**AMENDMENTS TO THE DRAWINGS:**

### **REMARKS**

### **Objections to the Drawings**

FIG. 1A

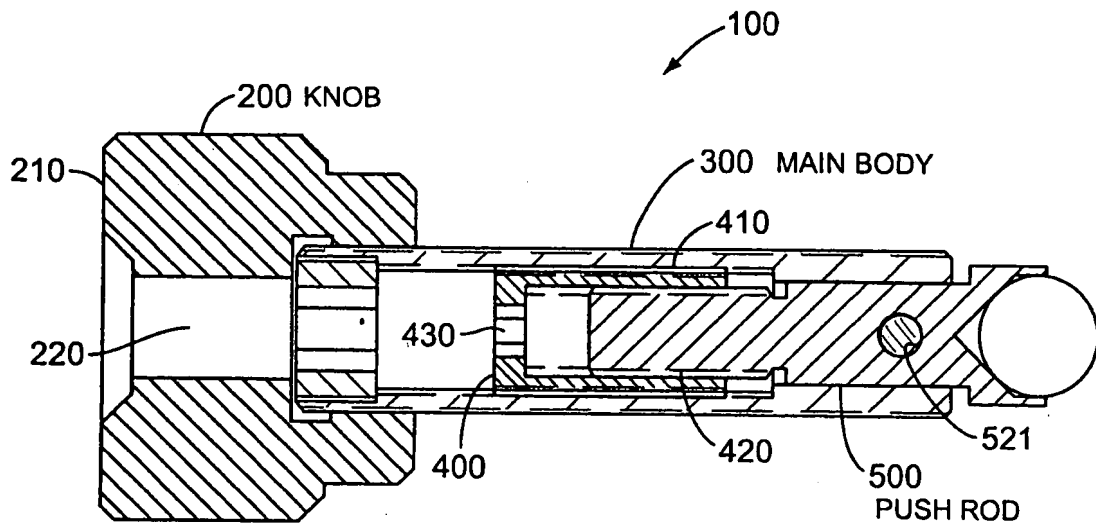
With respect to **Item 6(a)**, the dowel pin 521, the housing 300, and the push rod 500 are shown in the amended FIG. 1A and FIG. 1C. FIGS. 2A and 2B now better show a slot 340

With respect to **Item 6(b)**, Applicants respectfully submit that FIG. 1A shows that the first threaded surface 410 is an external threaded surface and the second threaded surface 420 is an internal threaded surface.

In **Items 12 and 13, first section**, claims 4 and 28 were rejected because, as stated by the Examiner, it is unclear as to how dowel pin 521 engages both the housing 300 and the rod 500 as claimed. Applicants respectfully disagree with the Examiner's assertion.

The dowel pin 521 is clearly shown in FIG. 1A and FIG. 1C. With this response, Applicants amend FIGS. 1A and 1C to add fillings in the circle denoted by reference number 521 to show that it is a cross-sectional view of the dowel pin 521. Even before this amendment,

FIG. 1B

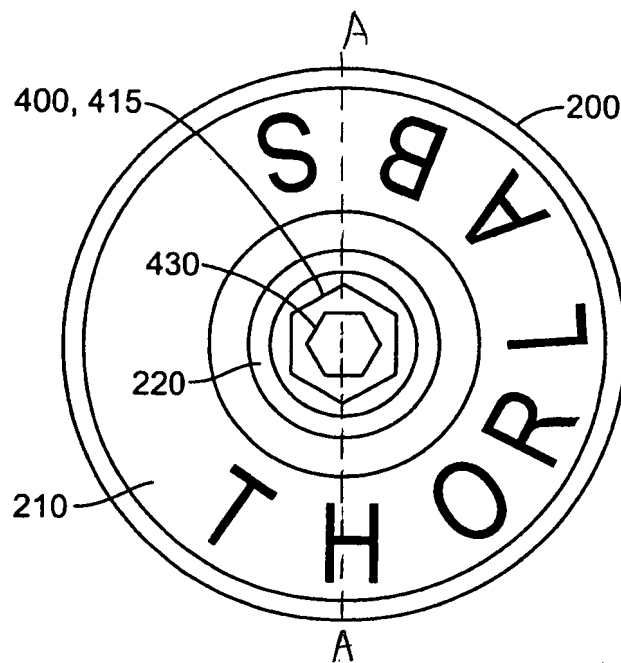
With respect to **Item 3(b)(2)** in the Office Action, Applicants have amended FIGS. 1B, 1D, and 1F and brief description of the drawings to show the sectional plane, upon which the cross-sectional views of the figures were taken.

FIG. 1F

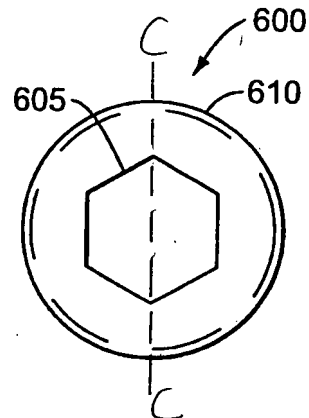
With respect to **Item 3(a)** in the Office Action, Applicants amend the specification to add a new paragraph briefly describing FIG. 1F (please refer to the Amendments to the Specification section).

FIG. 1G

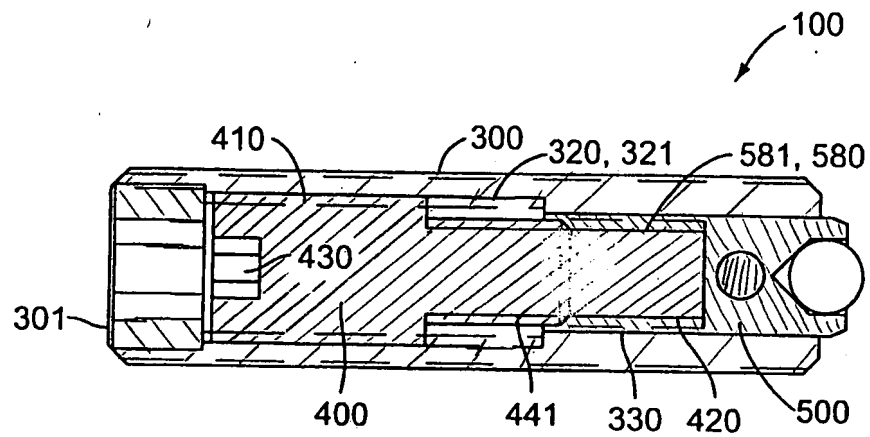
With respect to **Item 3(b)(1)** in the Office Action, Applications have amended FIG. 1G to show a cross-sectional view.

With respect to **Item 6(c)**, Applicants respectfully submit that FIG. 1G shows that the first threaded surface 410 and the second threaded surface 420 are both external threaded surfaces.

In **Item 13, third section**, claims 6 and 30 were rejected as it is unclear how the first and second threaded surfaces 410 and 420 are external surfaces. Applicants respectfully submit that FIG. 1G (originally FIG. 1F) clearly shows that the first threaded surface 410 and the second threaded surface 420 are external to the sleeve 400. Moreover, the structure is described in the specification. For example, paragraph [049] of the specification describes that “[i]n the embodiment shown in FIG. 1G, both first threaded surface 410 and second threaded surface 420 of intermediate actuator sleeve 400 are formed on an external surface 441 of intermediate

actuator sleeve 400.” Applicants respectively submit that, in view of FIG. 1G, and the corresponding description in the specification, a person skilled in the art should appreciate that the first threaded surface 410 and the second threaded surface 420 can be external surfaces.
